Final Decision Document
for the Interim Response Action
for the Improvement of the North Boundary System
at Rocky Mountain Arsenal
Via Construction of Groundwater Recharge Trenches

FINAL DECISION DOCUMENT
FOR THE INTERIM RESPONSE ACTION FOR
THE IMPROVEMENT OF THE NORTH BOUNDARY SYSTEM
AT ROCKY MOUNTAIN ARSENAL
VIA CONSTRUCTION OF GROUNDWATER RECHARGE TRENCHES

RESPONSE TO US EPA REVIEW COMMENTS
ON PROPOSED DECISION DOCUMENT FOR
THE INTERIM RESPONSE ACTION FOR THE
IMPROVEMENT OF THE NORTH BOUNDARY SYSTEM
AT ROCKY MOUNTAIN ARSENAL VIA CONSTRUCTION
OF GROUNDWATER RECHARGE TRENCHES

RESPONSE TO STATE OF COLORADO REVIEW
COMMENTS ON PROPOSED DECISION DOCUMENT FOR
THE INTERIM RESPONSE ACTION FOR THE
IMPROVEMENT OF THE NORTH BOUNDARY SYSTEM
AT ROCKY MOUNTAIN ARSENAL VIA CONSTRUCTION
OF GROUNDWATER RECHARGE TRENCHES

Figure 3. Generalized Alluvial Groundwater Flow Across RMA

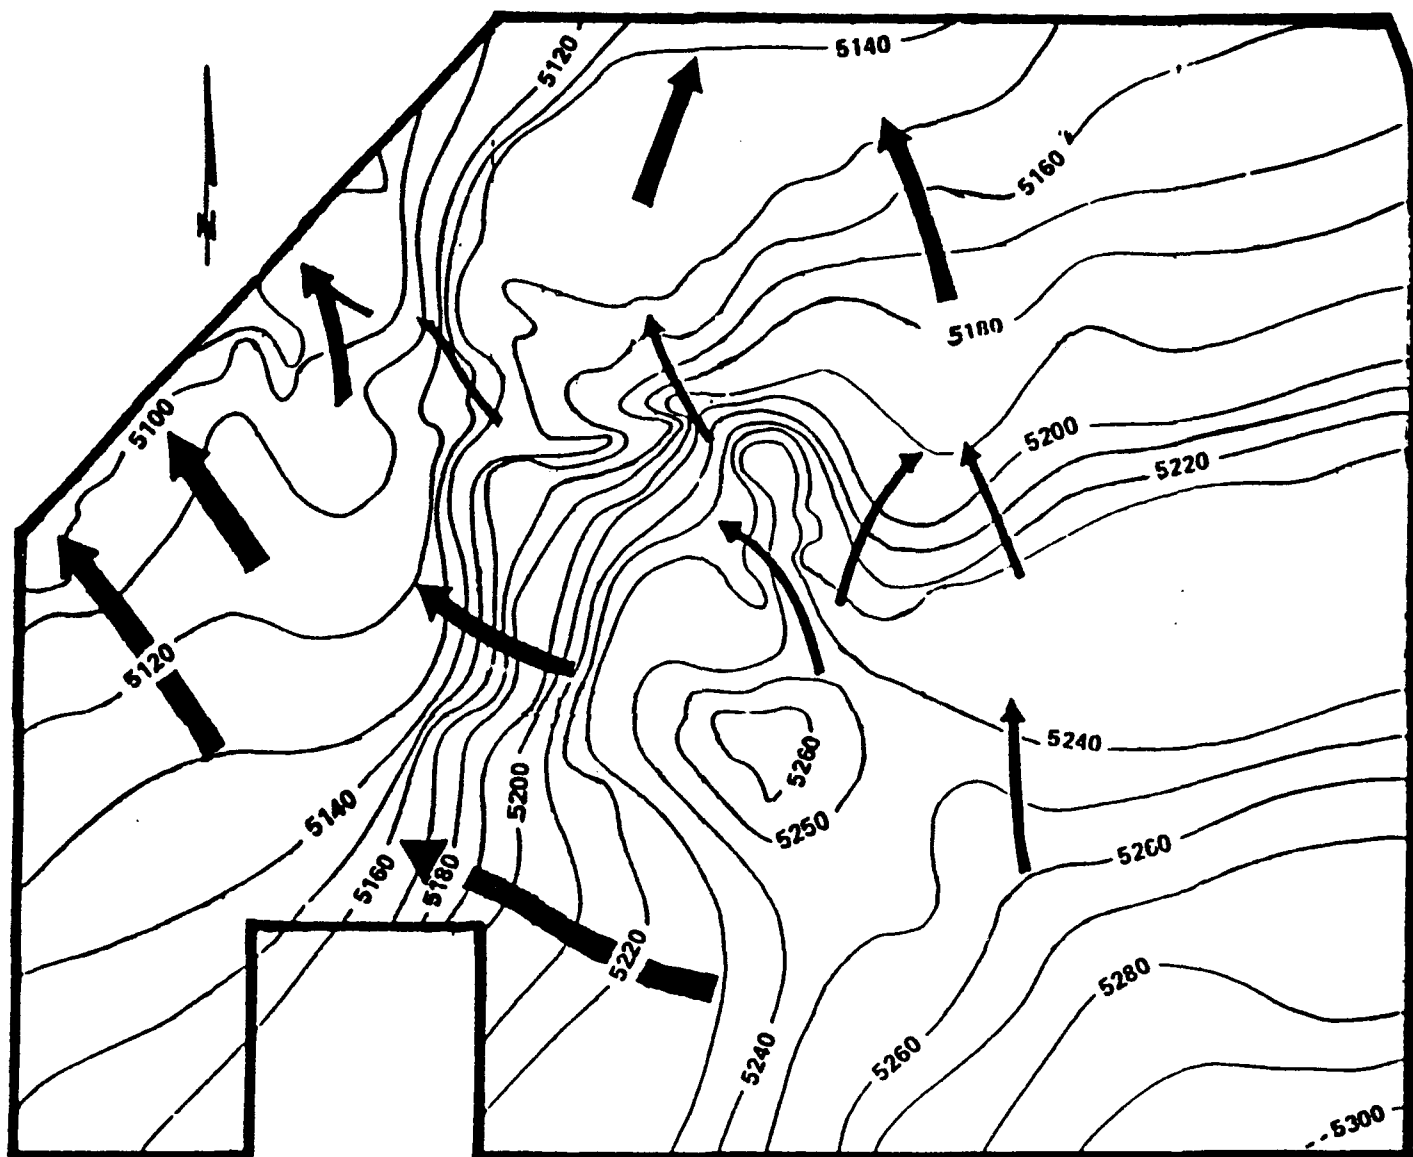
3. Pg. 2, para. 3. The second sentence should indicate that, generally alluvial groundwater beneath RMA flows from southeast to northwest and that Figure 3 represents generalized alluvial groundwater flow across RMA. Emphasis added.

4. Pg. 5, Figure 3. See Specific Comment ³/₅.

3. Page 2, paragraph 3. Emphasize text to clarify generality.

4. Page 5, paragraph 3. See specific comment 3.

Response: The text shall be modified as follows: "Alluvial groundwater beneath RMA generally flows from southeast to the northwest. Figure 3 represents the generalized alluvial groundwater flow across RMA."

Response: The description for Figure 3 shall be modified as follows: "Generalized Alluvial Groundwater Flow Across RMA."
